Access Compliance Report

Public Rights-of-Way

| Intersection ID: 9440 | Main Street: BRADFORD_DR | Cross Street: EDGEWOOD_RD | Location: W |
| ADA ID: F0591B48C5E2 | Ramp Type: Perp | Initial Pass/Fail: Fail | Overall Compliance: No |

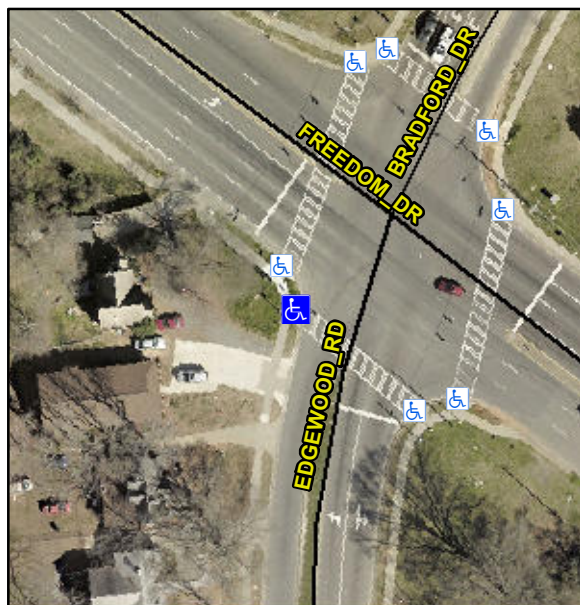
Not Found, R304.2.2

| Compliance | Description | Data | Compliance | Description | Data |
|------------|-----------------------|-------|------------|-----------------------------|------|
| N/A | Ramp Length (in) | 60.0 | No | Ramp Slope (%) | 9.5 |

Remove & Replace Entire Ramp.
